DEPARTMENT OF TRANSPORTATION**National Highway Traffic Safety Administration****49 CFR Parts 571 and 585****[Docket No. NHTSA–2007–27986]****RIN 2127–AJ96****Federal Motor Vehicle Safety Standards; Head Restraints****AGENCY:** National Highway Traffic Safety Administration (NHTSA), DOT.**ACTION:** Final rule; response to petitions for reconsideration.

SUMMARY: This document completes the agency's response to petitions for reconsideration of the December 2004 final rule upgrading our head restraints standard. We are partially granting and partially denying the petitions.

Figure 1. Risk of Whiplash Injury versus Head to Torso Rotation on the Hybrid III 50th percentile male dummy

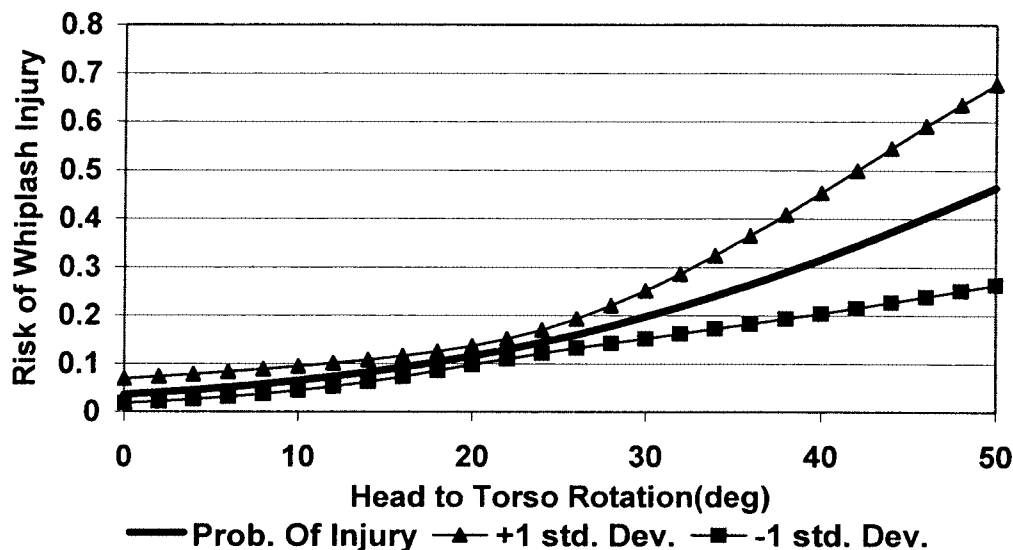
Unfortunately, the agency incorrectly presented in the final rule preamble a graph of head displacement rather than

head rotation (69 FR at 74874). The graph should have been the following:

This correct graph addresses some of the questions raised by the petitioners.

Figure 4 of §571.202a – Portion of gap above 540 mm height.

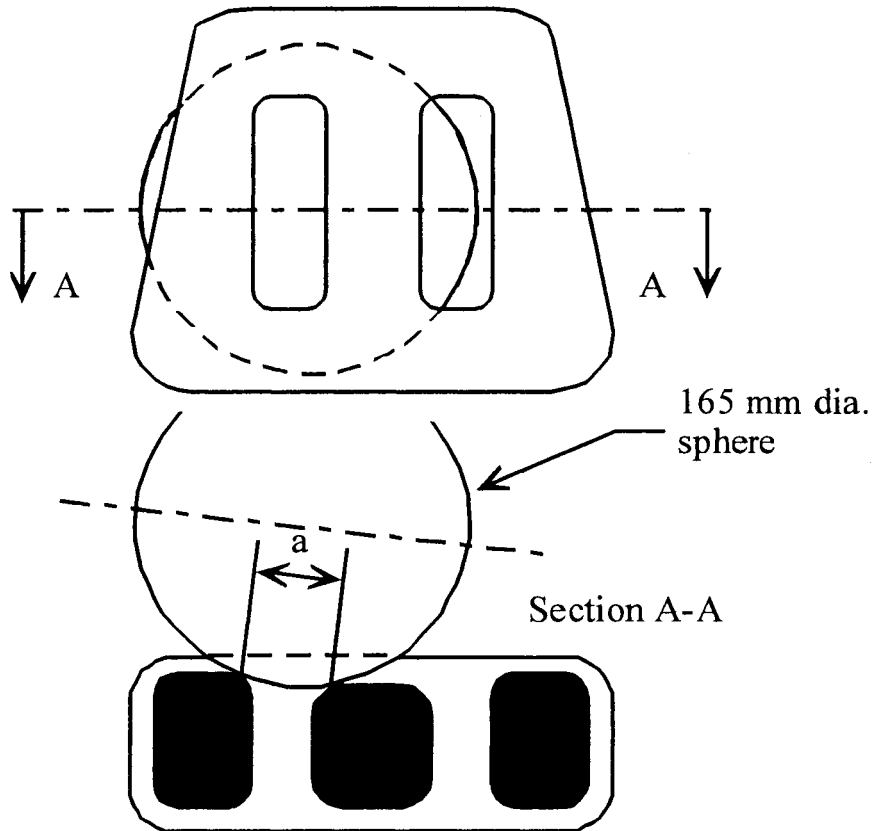
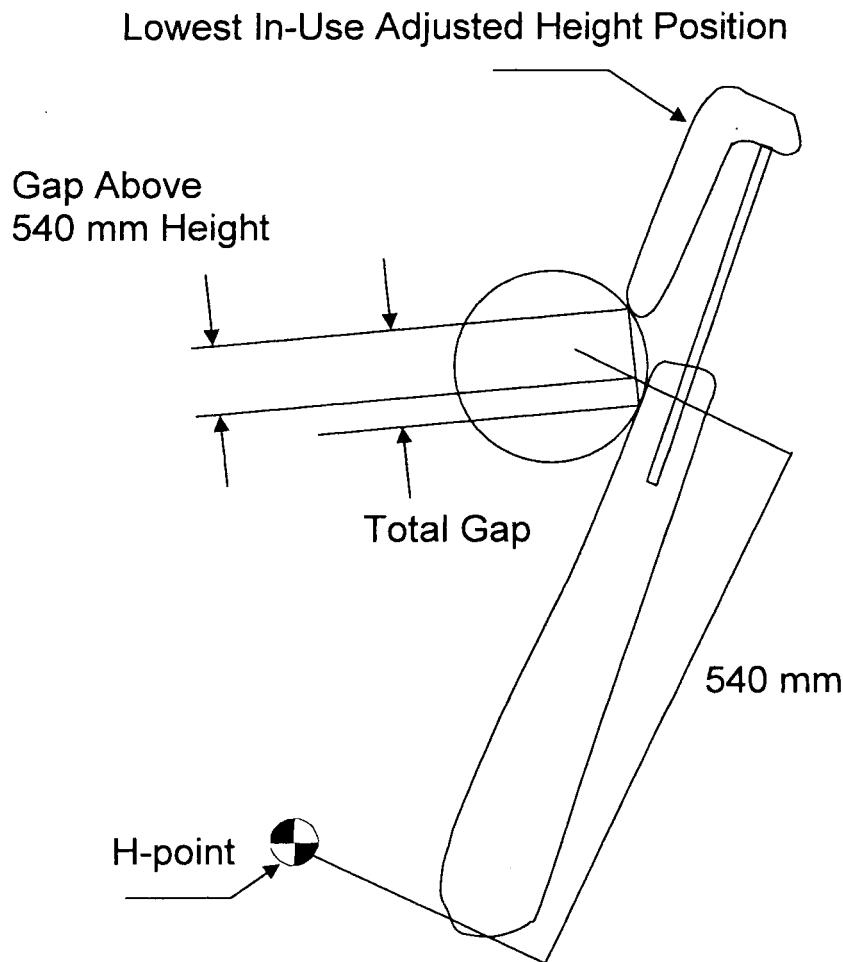
Also, we are adding a new Figure 4 that we believe will help clarify the requirement when using the sphere.
